ADDENDUM NO. 1

RFQ CCC-078

**Administration Building Renovation
Compton Community College District**

tBP Project. No. 20987.00

30. Revised Sheet E2-1 Power Plan

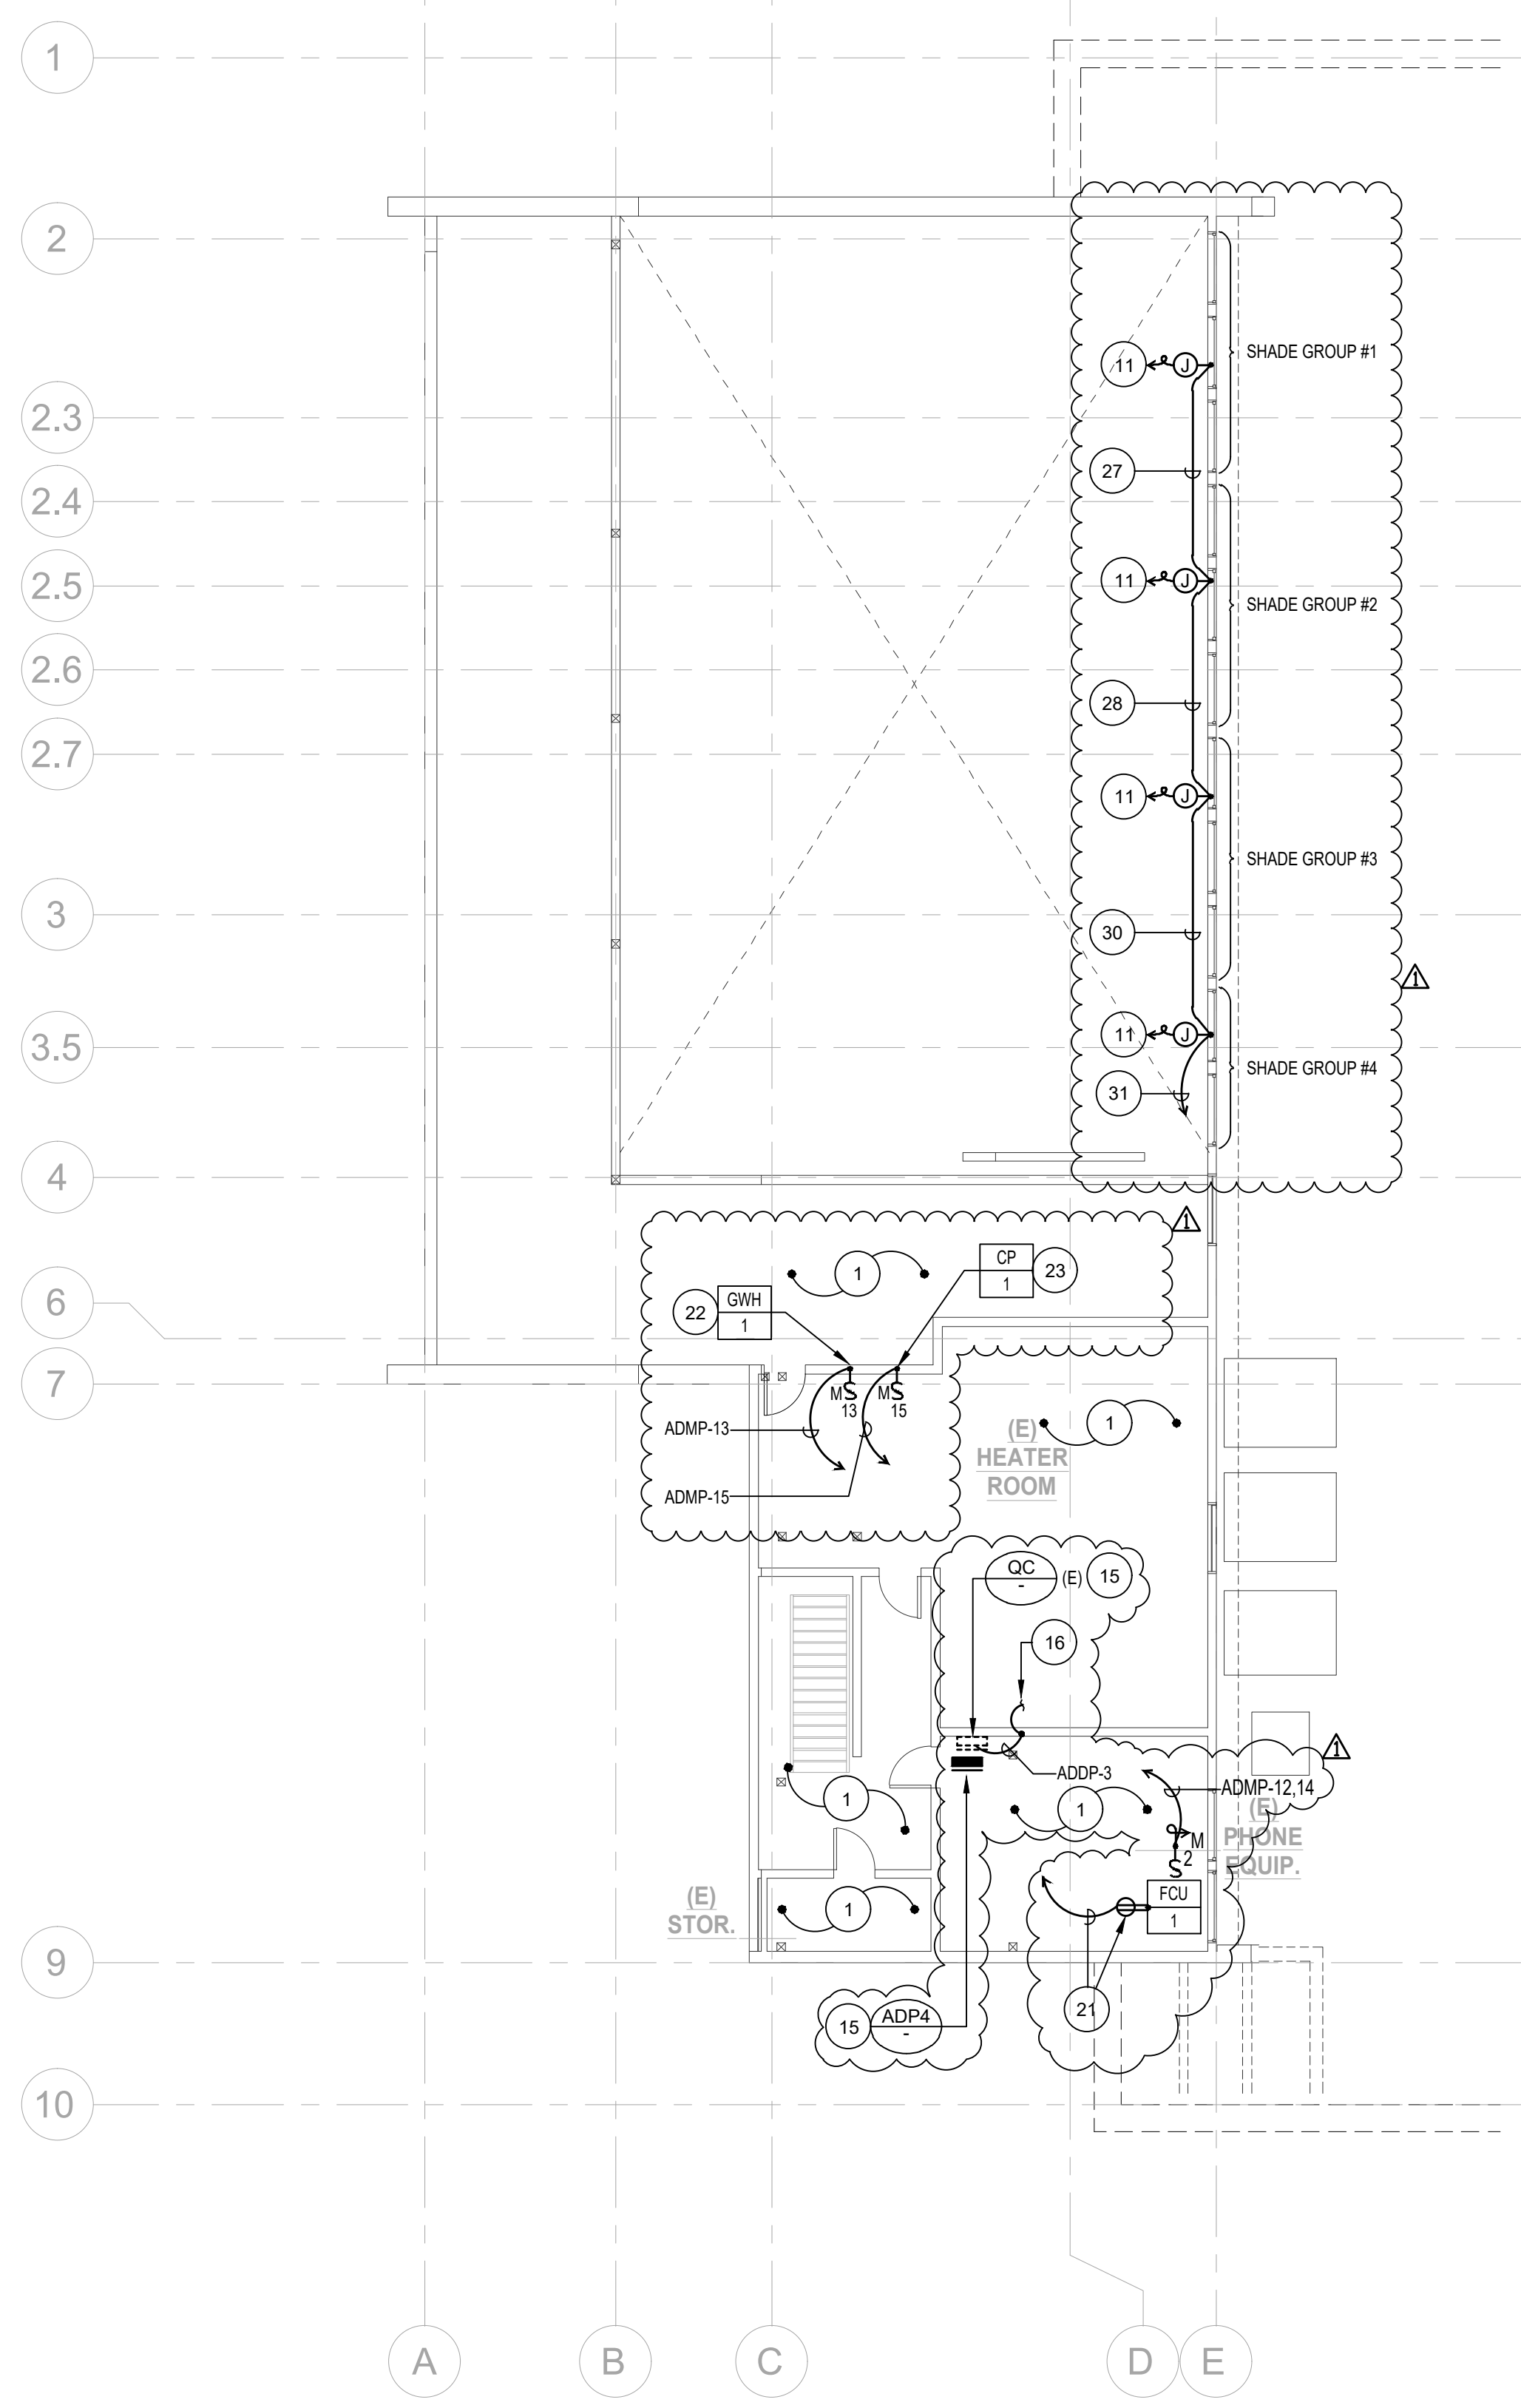
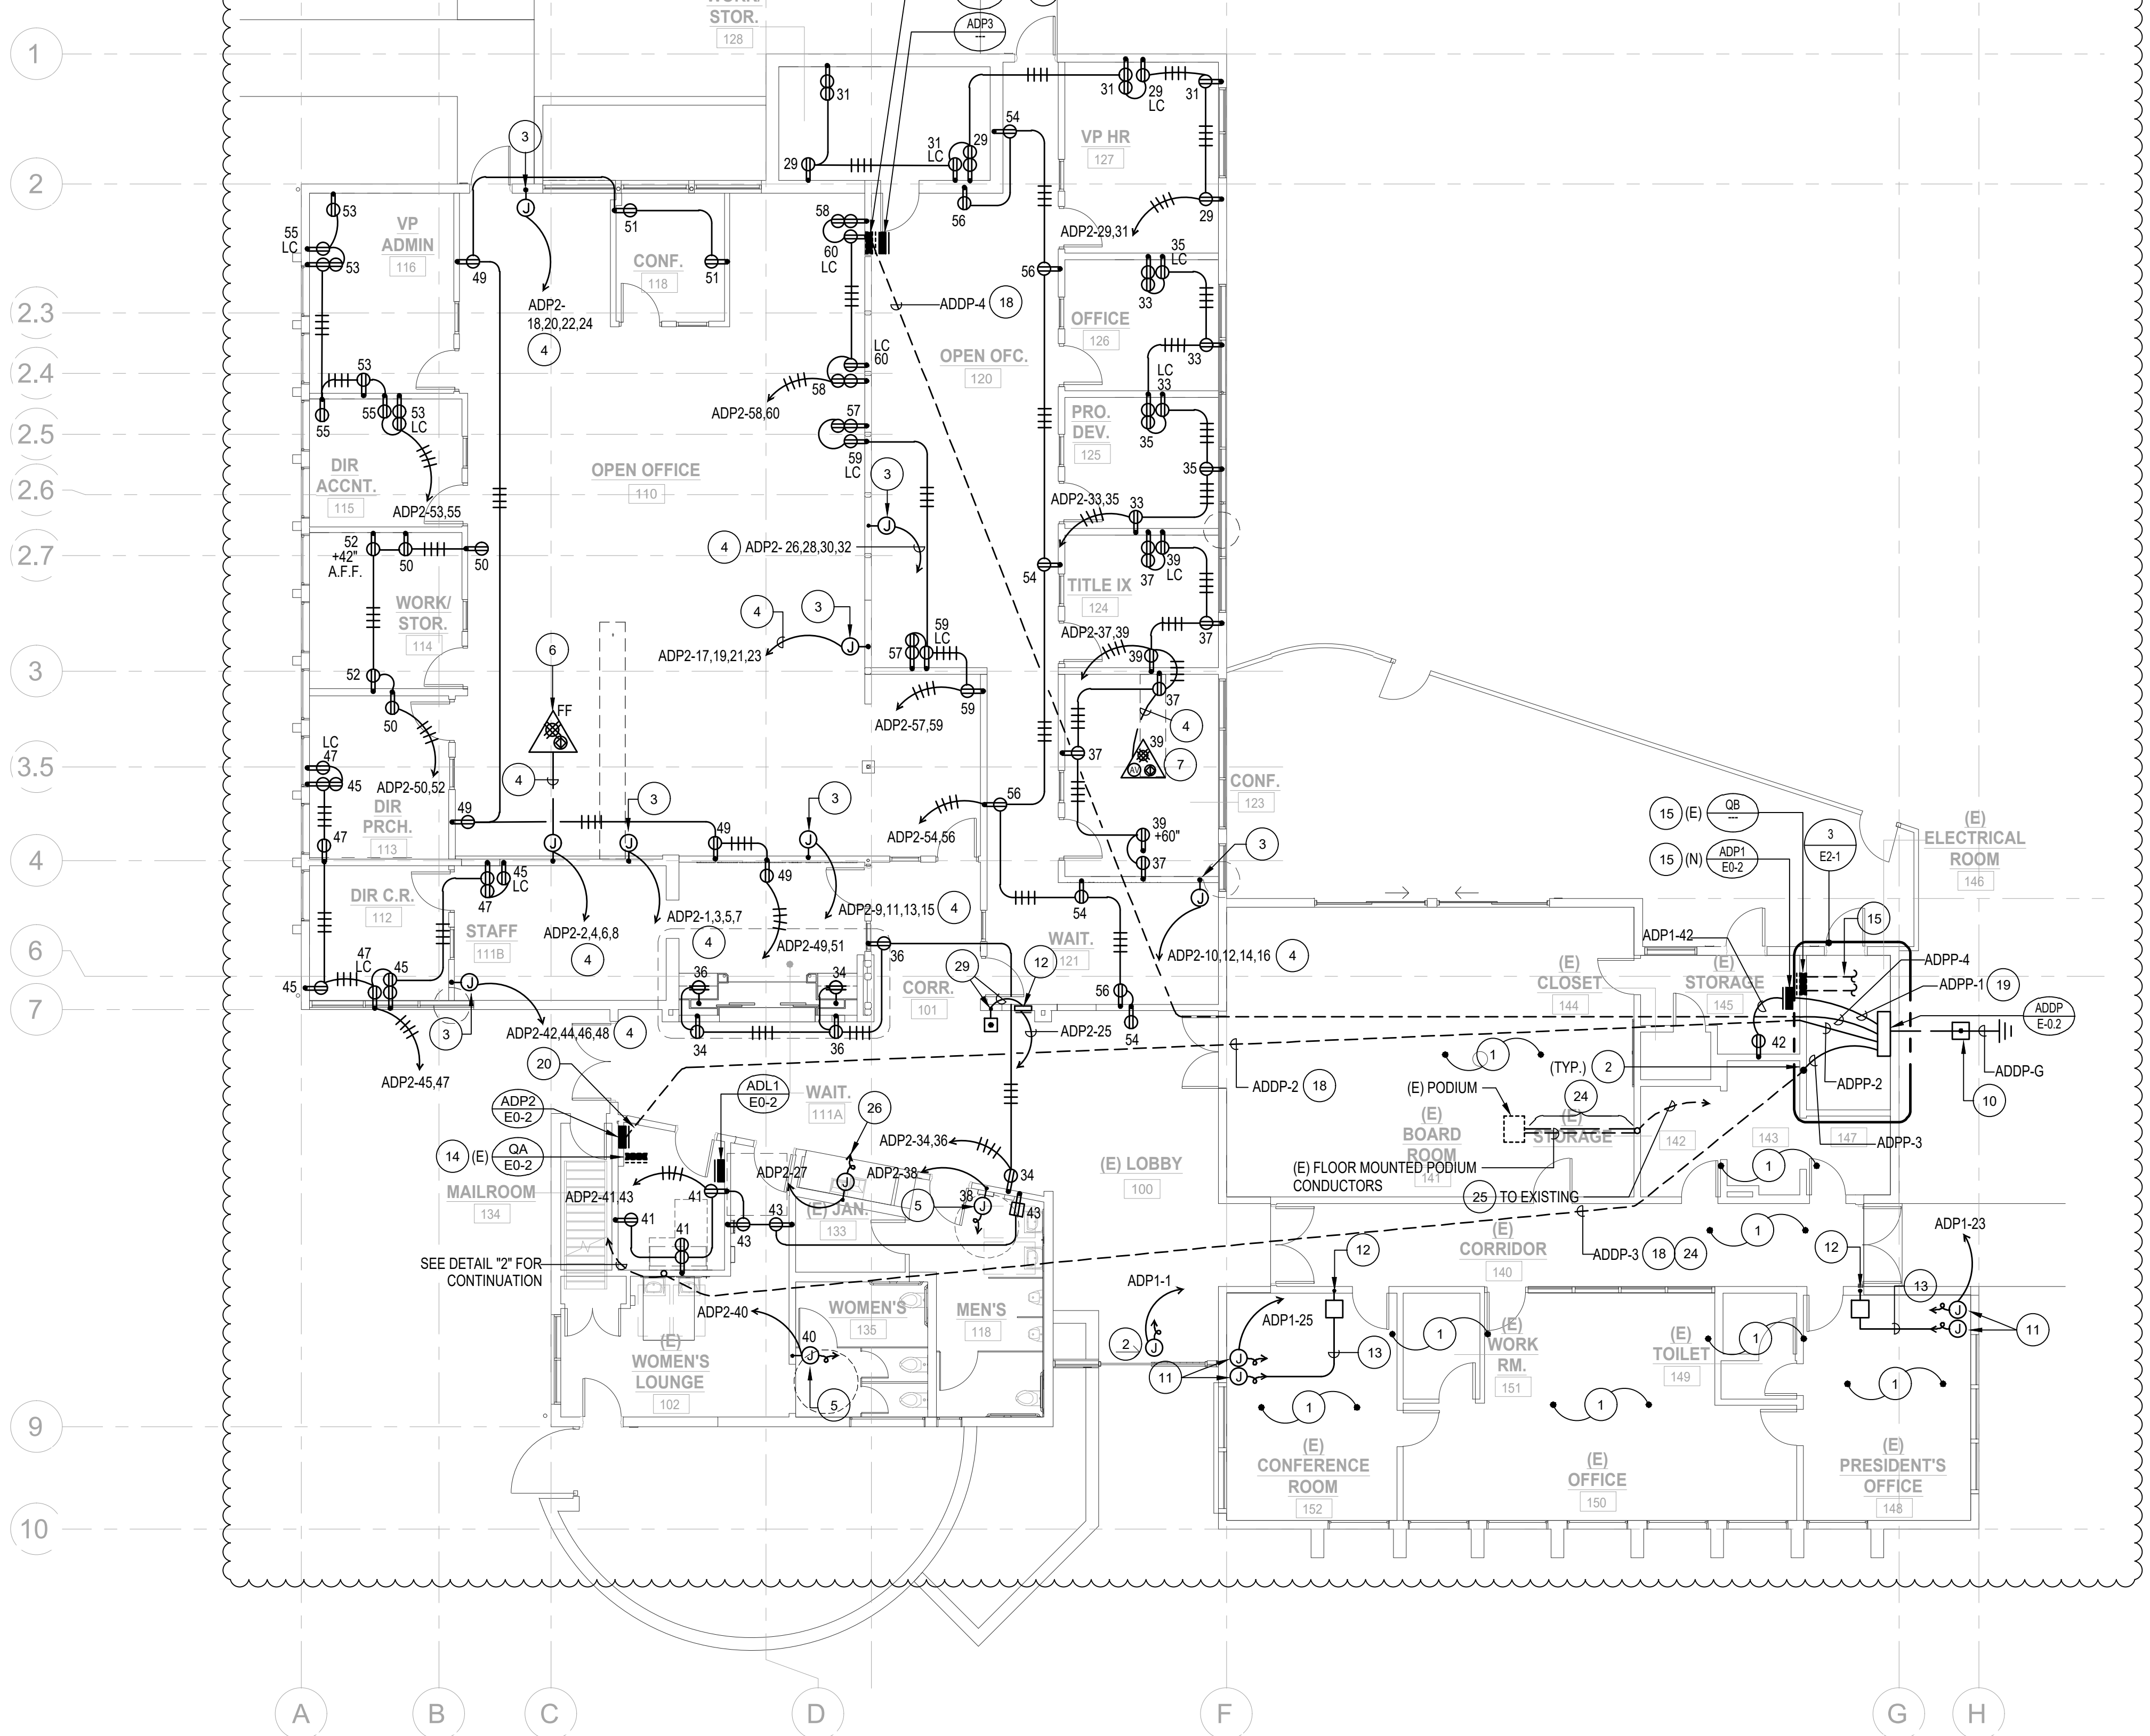
- a. Deleted old panels and added new panels at the same location of existing panels.
- b. Revised electrical room layout and room's demolition plan.
- c. Revised electrical room new plan.
- d. Indicated existing feeders under slab conduits and utilize them for new conductors.
- e. Revised roller Shade System power and control.
- f. Added power to new water heater and circulation pump indicated on Detail #2.
- g. Added power to roller Shade System indicated on Detail #2.
- h. Revised Plan Notes.
